# MEMORANDUM

**RE:** 8183

**SUBJECT:** Response to 2<sup>nd</sup> Traffic Review  
Proposed 40B Residential Development  
274 Water Street, Pembroke, Massachusetts

Figure -  
Conceptual Improvement Plan  
Church Street at Water Street

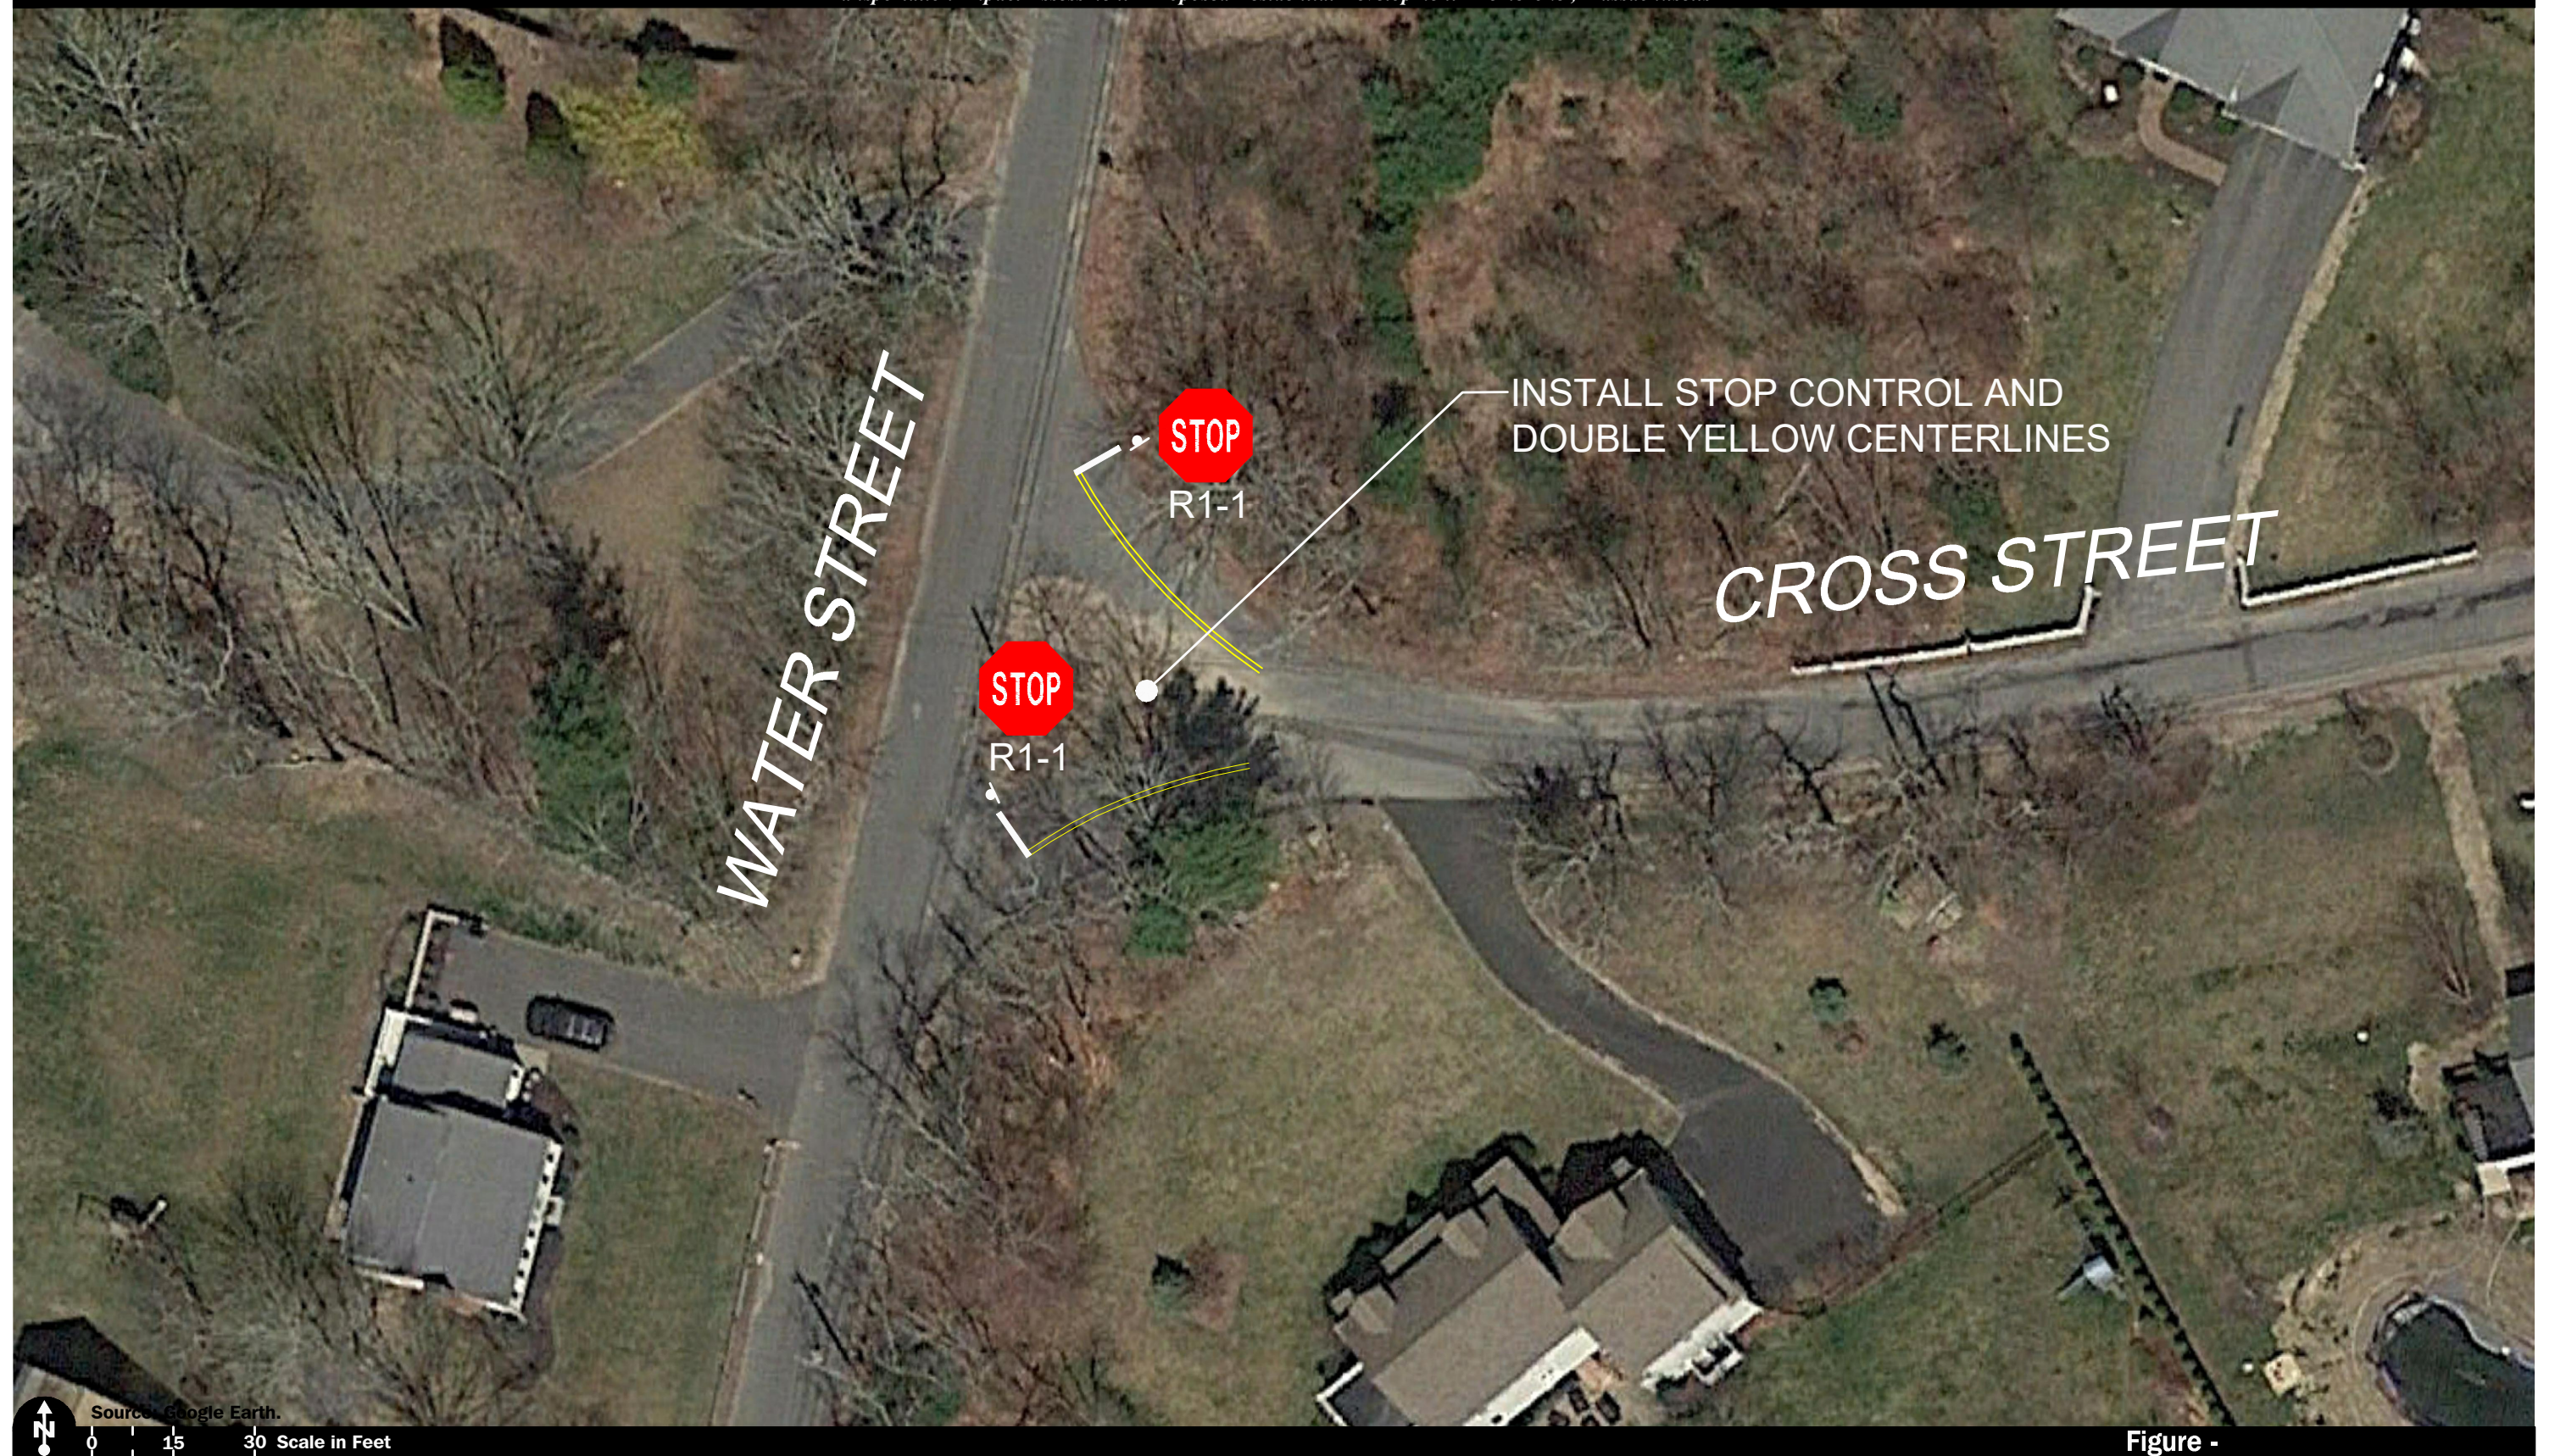
**Comment 15:** “Based on the above commitments, **we recommend the applicant submit a conceptual plan showing the recommended improvements for review, including how Water Street will be realigned, what signs are proposed, and where vegetation and roadside fixtures will be trimmed and/or removed.** Without such a plan, the specific actions proposed and limits of work cannot be ascertained. If MassDOT approval for these improvements is required, then the applicant should submit the necessary permit application to MassDOT. MassDOT is not likely to deny a request for improvements to their streets.”

**Response:** As requested by RMA, a conceptual improvement plan for the intersection of Church Street with Water Street is included as an attachment to this document. Proposed improvements, which are subject to MassDOT review and approval, include the installation of new pavement markings to better delineate inbound and outbound turning paths for vehicles turning to and from Water Street, as well as the provision of a short left-turn pocket for vehicles turning left onto Church Street, that will allow right-turning vehicles to bypass on the right. All new pavement markings and signage will be installed in accordance with *Manual on Uniform Traffic Devices* (MUTCD)<sup>3</sup> design criteria. The applicant is also committed to cutting back existing vegetation within the Town of Pembroke and MassDOT right-of-way, north of the intersection, to improve sight lines in this direction.
